UNITED STATES PATENT AND TRADEMARK OFFICE

APPLICATION NO.	FILING DATE	FIRST NAMED INVENTOR	ATTORNEY DOCKET NO.	CONFIRMATION NO.
09/918,886	07/30/2001	Ting K. Yee	20852-05682	3294

Office Action Summary

Drawings

FIG. 16

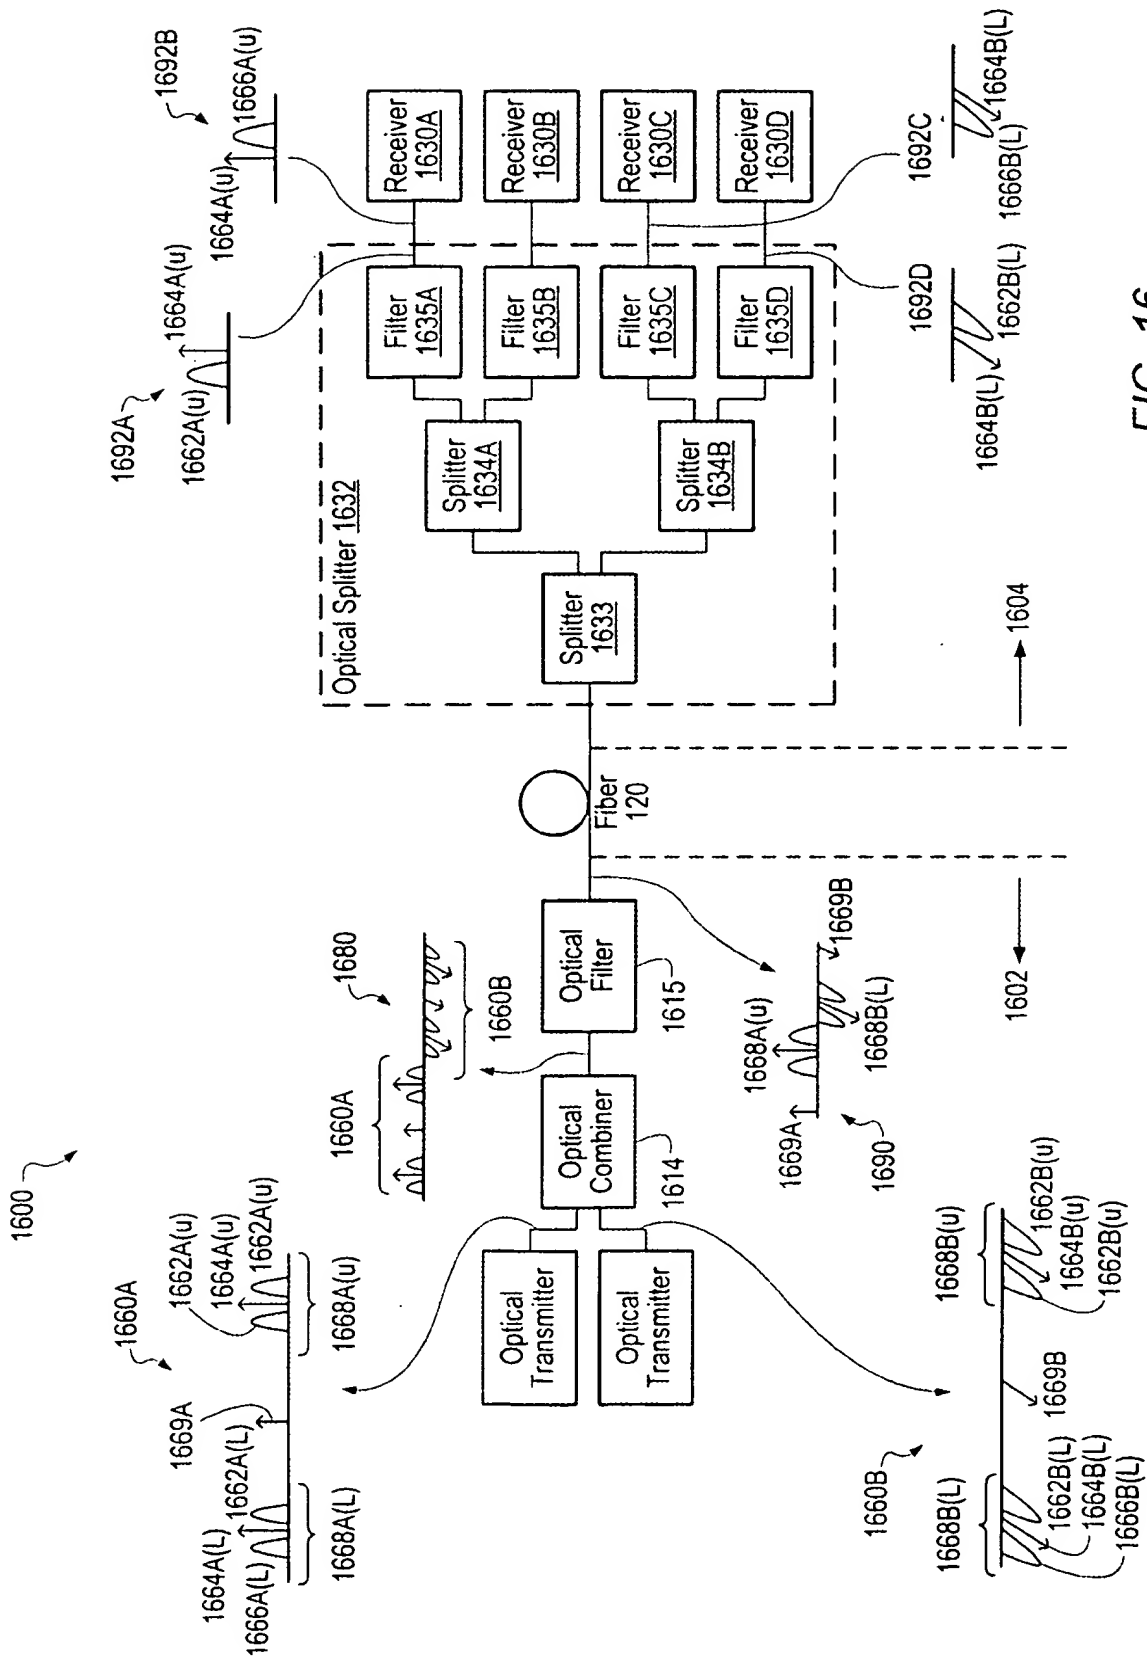
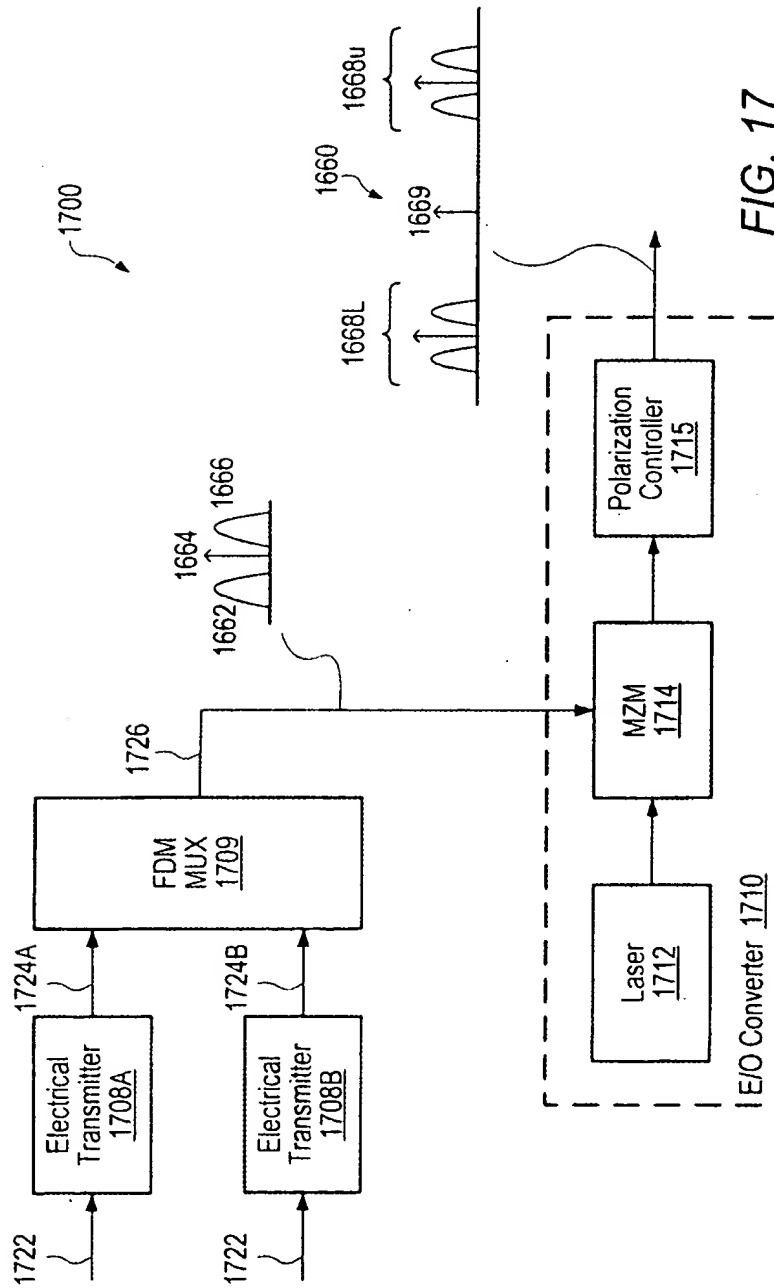
In Fig. 16, label the upper optical transmitter with “1610A” as in old Fig. 16 filed on 30 July 2001. Also, label the lower optical transmitter with “1610B” as in old Fig. 16 filed on 30 July 2001. Otherwise, the reference character “1610” in paragraphs [0043, 0047, 0050, 0054] is not in the figures. Also, see paragraph [0108] for support.

In Fig. 16, replace the rightmost “1662A(u)” with “1666A(u)” as shown in old Fig. 16 filed on 30 July 2001. See paragraph [0109] for support.

In Fig. 16, replace the rightmost “1662B(u)” with “1666B(u)” as shown in old Fig. 16 filed on 30 July 2001. See paragraph [0110] for support.

In Fig. 16, extend the lead line for spectrum 1692B to the input line for receiver 1630B. Otherwise, Fig. 16 shows spectrum 1692A and 1692B for the input line to receiver 1630A.

FIG. 18A

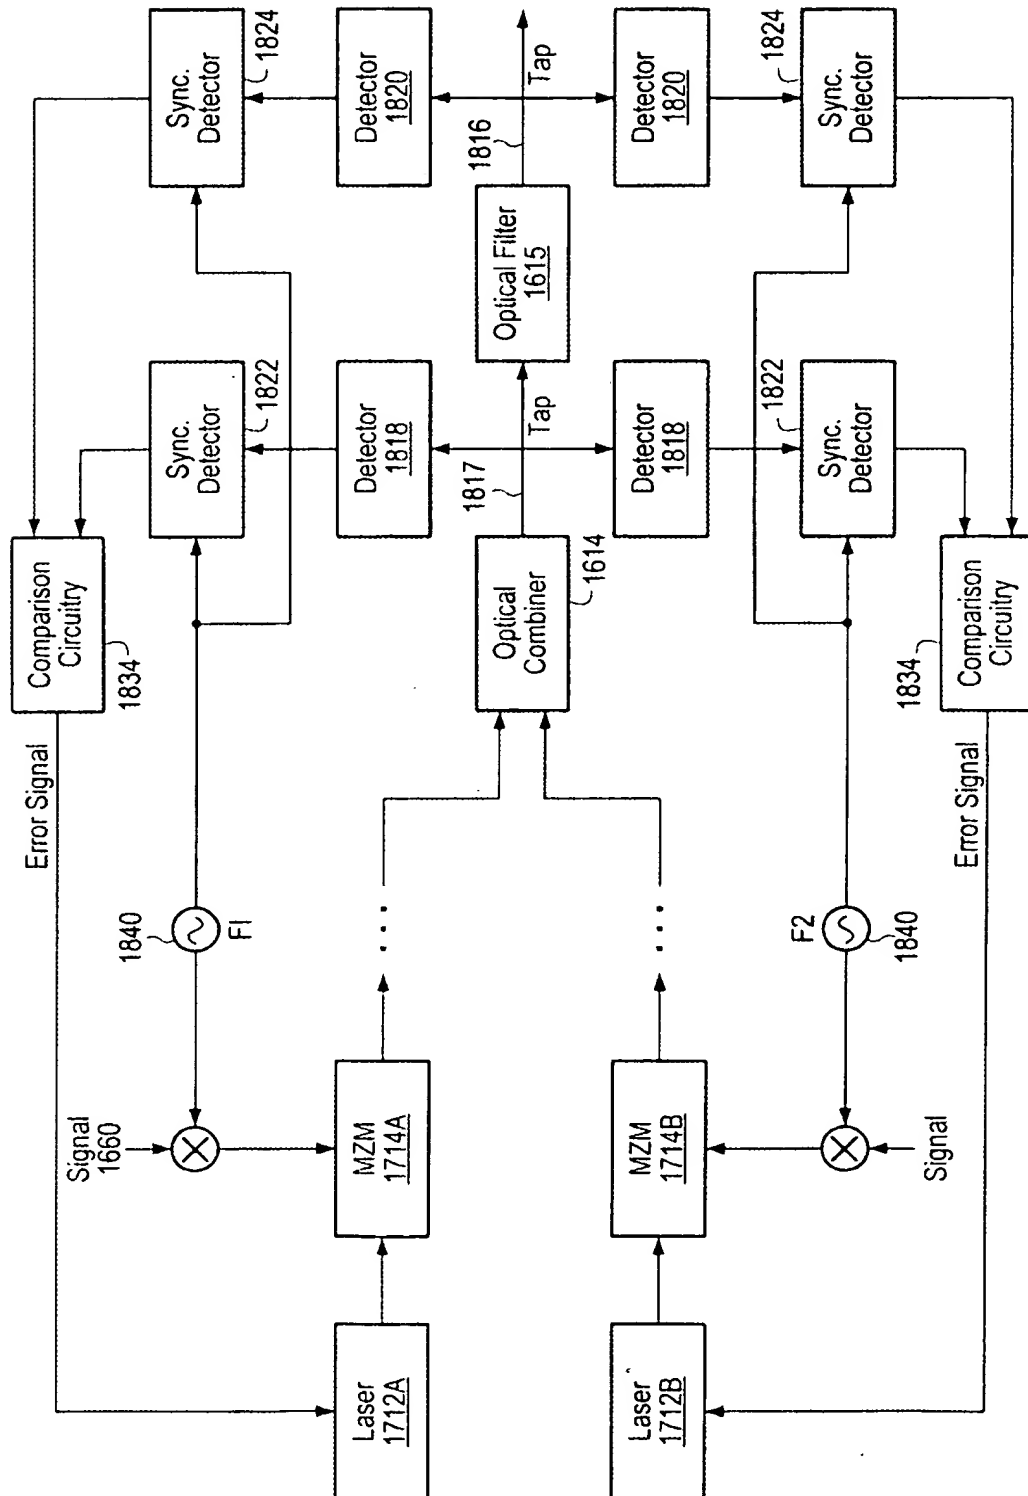
Applicant responded to the drawing objection regarding **claim 13** by amending Fig. 18A to show all of the features recited in claim 13. However, amended Fig. 18A is disapproved. In Fig. 18A, much of the bottom half is not supported by the specification and constitutes new matter. For example, the original disclosure does not disclose the bottom detectors 1818 and 1820, the bottom sync detectors 1822 and 1824, the bottom comparison circuitry 1834, and the associated connections. Rather, Fig. E-23B in provisional application 60/265,251 supports just one detector 1818, one detector 1820, one sync detector 1822, one sync detector 1824, one comparison circuitry 1834, and the associated connections. Accordingly, the drawing objection to claim 13 remains. The drawings remain objected to under 37 CFR 1.83(a). The drawings must show every feature of the invention specified in claim 13. No new matter should be entered. As a remedy, Examiner respectfully suggests amending Fig. 18A to correspond more closely to supported Fig. E-23B in provisional application 60/265,251.

In Fig. 18A, add a reference character “1800” that points to the entire device. See paragraphs [0044-0045, 0126] for support.

In Fig. 18A, much of the bottom half is not supported by the specification and constitutes new matter. For example, the original disclosure does not disclose the bottom detectors 1818 and 1820, the bottom sync detectors 1822 and 1824, the bottom comparison circuitry 1834, and the associated connections. Rather, Fig. E-23B in provisional application 60/265,251 supports just one detector 1818, one detector 1820, one sync detector 1822, one sync detector 1824, one comparison circuitry 1834, and the associated connections. Amend Fig. 18A to correspond more closely to supported Fig. E-23B in provisional application 60/265,251.

FIG. 18B

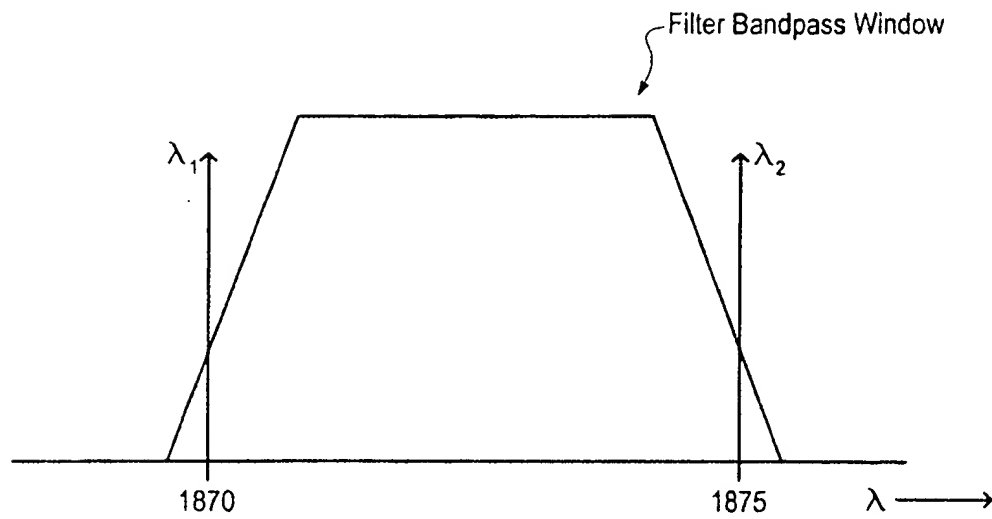
However, paragraphs [0131-0132] teach the use of a ratio for **each** optical signal. Fig. 18B shows multiple (2) signals, each signal requiring the use of its own associated ratio. The disclosure does not

FIG. 22

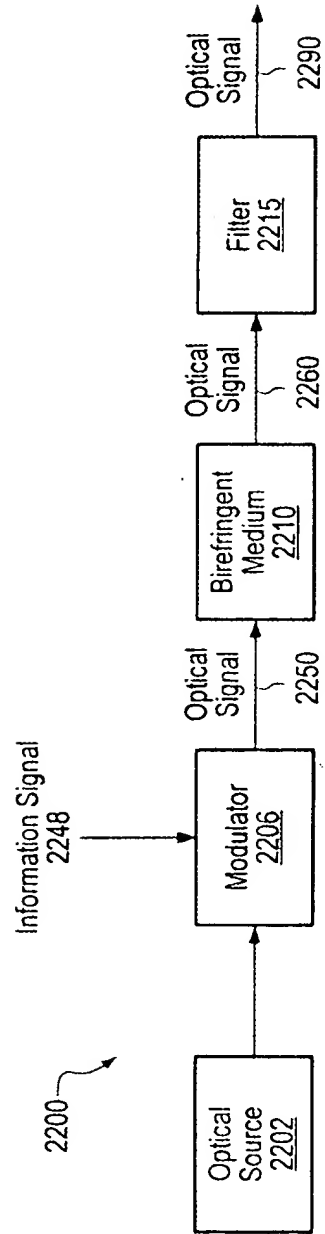
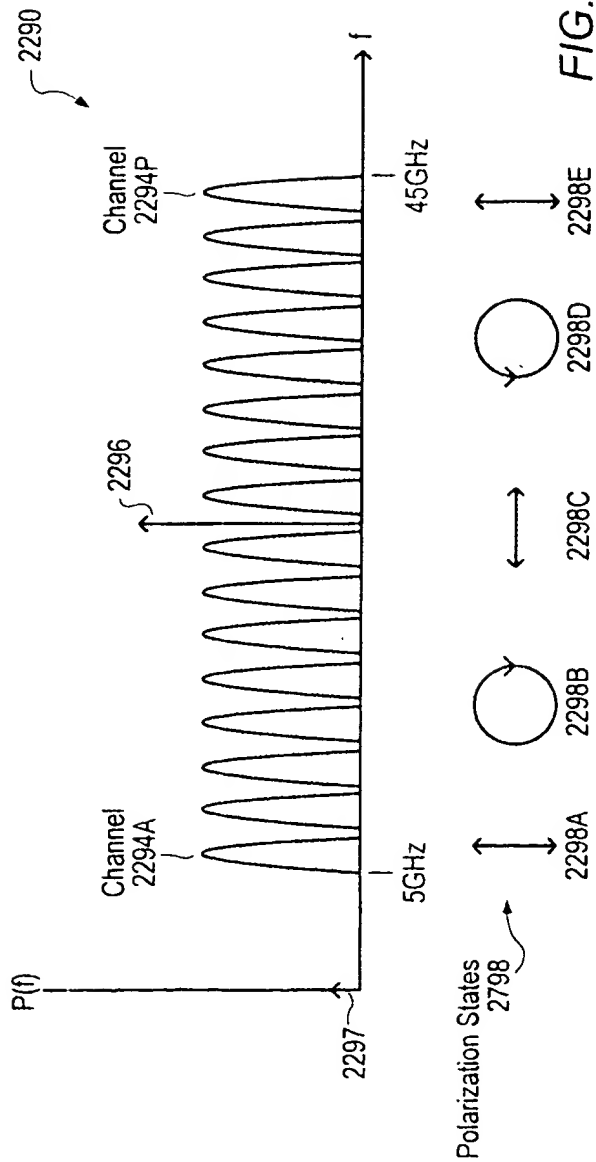
Applicant responded to the drawing objection regarding **claim 5** by pointing to Fig. 22 as support for the claim language in claim 5. However, Fig. 22 is directed to non-elected Species II (designated in an Office Action mailed on 03 November 2004). Accordingly, the drawing objection to claim 5 remains. The

drawings remain objected to under 37 CFR 1.83(a). The drawings must show every feature of the invention specified in claim 5. No new matter should be entered. As a remedy, Examiner respectfully suggests the submission of a new figure showing the limitations of claim 5 or the cancellation of claim 5.
